## **CABINET MEMBER FOR HIGHWAYS MANAGEMENT – 3 JUNE 2021**

### **HARWELL: GROVE ROAD AND ADJACENT ROADS – PROPOSED 20MPH AND 40MPH SPEED LIMITS**

Report by Corporate Director, Environment and Place

TRAFFIC REGULATION ORDER PLAN  
SHEET 1 OF 2

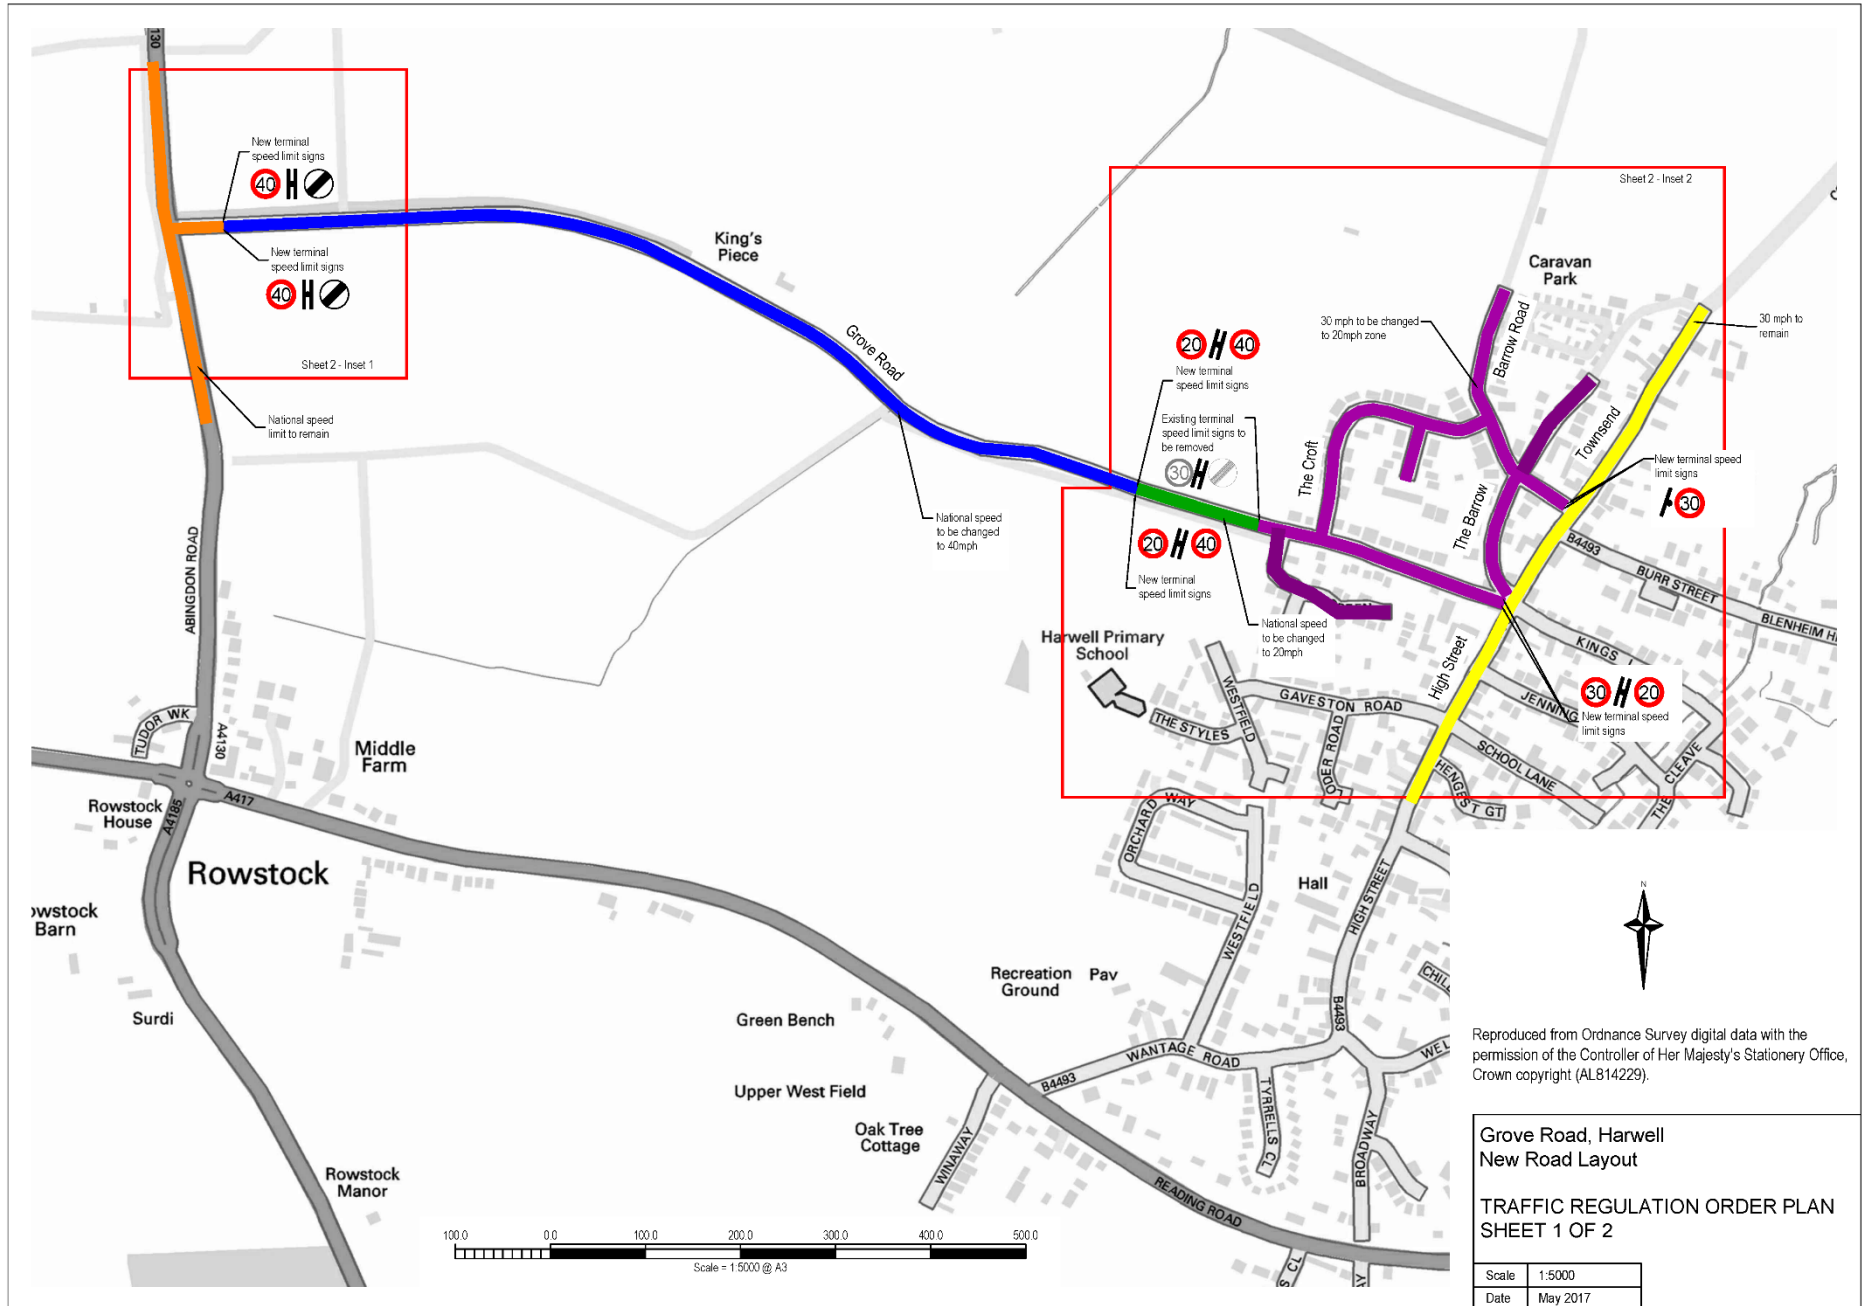
8. Thames Valley Police objected to the proposed 40mph and 20mph limit on Grove Road (though had no objection to the proposed 20mph limit proposed on the other roads) on the grounds that they did not consider that these limits would be consistent with guidance issued by the Department for Transport (DfT) and specifically in relation to the advice that 20mph limits should be self-enforcing. While accepting that average speeds close to the terminal of the 20mph limit are above the 24mph threshold recommended in the DfT guidelines, speeds will typically be appreciably higher than the posted speed limit close to a terminal sign and it is considered that this does not undermine the justification for a 20mph limit which otherwise is consistent with DfT guidance.

RESPONDENT	COMMENTS
<p>(1) Traffic Management Officer, (Thames Valley Police)</p>	<p><b>Object</b> – My response to this previous proposal dated 10th August 2017 remains in place (see below). I am also aware having received documents from a consultant working on behalf of OCC that the Grove Road 20 has poor compliance and should be further engineered or replaced by a more realistic speed limit .</p> <p>[10/08/2017] - 20 mph speed limits should be self-enforcing and current speeds already 24 mph or less.</p> <p>The policy of Thames Valley Police is to use sound practical and realistic criteria (Circular Roads 1/2013) when responding to Highway Authorities in an effort to promote consistency and to reduce the burden of constant and unnecessary enforcement. The advice shown in Circular Roads 1/2013 states Speed Limit should not be used to attempt to solve the problem of isolated hazards, for example a single junction or reduced forward visibility.</p> <p>Experience shows that changing to a lower speed limit on its own will not necessarily be successful in reducing the speed of traffic by very much if the prevailing mean speeds are much higher than the proposed lower speed limit. If a speed limit is set too low and ignored, then this could result in the majority of drivers criminalising themselves and could bring the system of speed limits into disrepute. There should be no expectation that the police would be able to provide regular enforcement if a speed limit is set too low as this could result in an unreasonable additional demand on police resources. It is also important to set reasonable speed limits to ensure consistency across the country.</p> <p>Therefore, speed limits should be considered as part of a package of measures to manage vehicle speeds and improve road safety. Changes to the highway (for example through narrowing, providing vertical traffic calming or re-aligning the road) may be required to encourage lower speeds in addition to any change in speed limit. Though these may be more expensive, they are more likely to be successful in the long term in achieving lower speeds without the need for increased police enforcement to penalise substantial numbers of motorists.</p> <p>In principle I do not object to the lowering of the speed limit on the urban roads leading from Grove Road .</p> <p>I do object to the current speed limit proposals for Grove Road both 40 and 20. Imposing a standalone 20 limit might give unrealistic expectations to the vulnerable user that the road is more safe when it is not due to poor compliance of the lower limit.</p>

<p>(2) Local Group, (Oxfordshire Cycling Network)</p>	<p><b>Support</b> – Reduced speeds have proven safety benefits and will make the streets safer for people walking and cycling, encouraging active travel and more active lifestyles, which is better for health in the long-term. 20mph is considered the right speed for residential areas, as set out in Manual for Streets, the accepted best practice for street design in the UK. It is completely appropriate to adopt these for the residential areas of Harwell and Dudcote Field, and in fact any higher limit should be considered anomalous.</p> <p>We are concerned about compliance with 20mph speed limits - evidence shows 82% of HGV, 85% of LCV and 86% of car drivers break these limits. However the limits do reduce speeds, and although the median is only reduced by 1mph, ""Vehicles travelling at higher speeds before the introduction of the 20mph limit have reduced their speed more than those already travelling at lower speeds"". <a href="https://www.gov.uk/government/statistics/vehicle-speed-compliance-statistics-for-great-britain-2019">https://www.gov.uk/government/statistics/vehicle-speed-compliance-statistics-for-great-britain-2019</a></p> <p>Grove Road is narrow and twisty with blind bends. Many motorists travel fast on this road and we have had some scary encounters while both cycling and driving. Reducing the speed on this road should be considered a priority and 40mph looks very appropriate. Additional calming measures at the pinch points (e.g. a 'Bend' sign or a painted SLOW) may be useful.</p>

<p>(3) Local Group, (Cycling UK, Wantage)</p>	<p><b>Support</b> – The 20mph limits proposed for Dudcote Fields and Harwell are appropriate for residential areas and will make those places safer for people walking and cycling, encouraging healthier lifestyles.</p> <p>I am the Chairman of Cycling UK Wantage and we often use Grove Road for leisure rides. Grove Road is narrow and twisty and is often used by people walking and cycling, and there is not always enough room for two vehicles to pass safely. Many drivers travel too fast to react safely to what is round a blind corner. The 40mph limit will make this road safer for all users.</p>
<p>(4) Local Resident, (Harwell)</p>	<p><b>Object</b> – I wish to object to the proposals as they lack the clarity required of such documents and should never have made it past whatever checking system OCC has in place before putting proposals to public consultation, particularly as it's the 2nd attempt at this.</p>

<p>Perhaps a pre-consultation with local councils would have been advisable if OCC no longer has people able to check the data or the consistency and accuracy of the documents. There are a number of errors of details such as road names and numbers, some of which would have come into force if the 2018 order had been implemented, so it should have been quite easy to check. Some suggest a lack of knowledge about the boundary between the Vale WHDC and SODC in GWP.</p> <p>Plus in Chilton Parish there is a length of the A4185 on both the 30 and 40 mph lists. It seems there is some division between roads in Harwell Parish - in the 'Harwell and various parishes' document and roads in Didcot town - in the Didcot document – but the latter seems ignorant of the fact that some roads have name changes at the District boundary.</p>
<p>(5) Local Business, (Milton Park)</p>	<p><b>Support</b> – The 20mph limits proposed for Dudcote Fields and Harwell are appropriate for residential areas and will make those places safer for people walking and cycling, encouraging healthier lifestyles.</p> <p>Grove Road is narrow and twisty and is often used by people walking and cycling, and there is not always enough room for two vehicles to pass safely. Many drivers travel too fast to react safely to what is round a blind corner. The 40mph limit will make this road safer for all users.</p>

<p>(6) Local Resident, (Harwell)</p>	<p><b>Support</b> – These measures are necessary to accustom road users in Harwell to a low speed limit throughout the village. The High Street has numbers of residential Lanes off it which have poor visibility both from and onto the High due to vehicles parked all the way along it, often very tight to junctions in contravention of the Highway Code. Householders in Church Lane, Harwell, met the County Roads Technician in March 2014 to explain how we felt sight lines could be improved. We were simply told to involve the police each time so that a record was built up of near misses caused by fast driving or inconsiderate parking on the High Street. The more traffic calming the better to encourage safe walking to school!</p>
<p>(7) Local Resident, (Harwell)</p>	<p><b>Support</b> – All villages and residential streets should have a 20 mph limit a) to help prevent accidents and b) very much in the case of Harwell Village, to encourage the use of the Harwell link road and reduce the main village road, especially Grove Road, being used as a rat run from Didcot to the Milton Park Roundabout. This becomes even more essential when Valley Park is built.</p>

<p>(8) Local Resident, (Harwell)</p>	<p><b>Support</b> – I live on Barrow Road. This area has young children playing in their gardens, walking on the paths and sometimes using scooters on the road. We were looking at the road signs regarding speed limits, and it really wasn't clear what the speed limit is for Barrow Road. When you leave the road, there is a 30mph signpost to join the High Street, therefore, we are assuming that Barrow Road is 20mph!</p>
<p>(9) Local Resident, (Harwell)</p>	<p><b>Support</b> – "As a resident of Harwell village, a 20mph speed limit through the village is very much needed. Cars, vans and motorbikes often speed through the village which is very dangerous.</p> <p>We also need speed cameras or average speed limit cameras on the Reading Road through Harwell as cars do not slow down to 30 mph."</p>
<p>(10) Local Resident, (Abingdon)</p>	<p><b>Support</b> – These are routes often used by pedestrians and cyclists and there is a tendency for some car drivers not to recognise the vulnerabilities of these people. Encouraging walking and cycling is both good for the individual's health but also has a positive impact on the environment and all our lives by reducing vehicle travel and so reducing pollution and CO2 emissions.</p>

9. Notwithstanding the above, the developers have agreed in principle – and subject to a further consultation – to fund additional traffic calming measures on Grove Road with in the 20mph limit. It is anticipated that consultation will be carried out in the summer with the responses reported to a future decisions meeting in the early autumn.
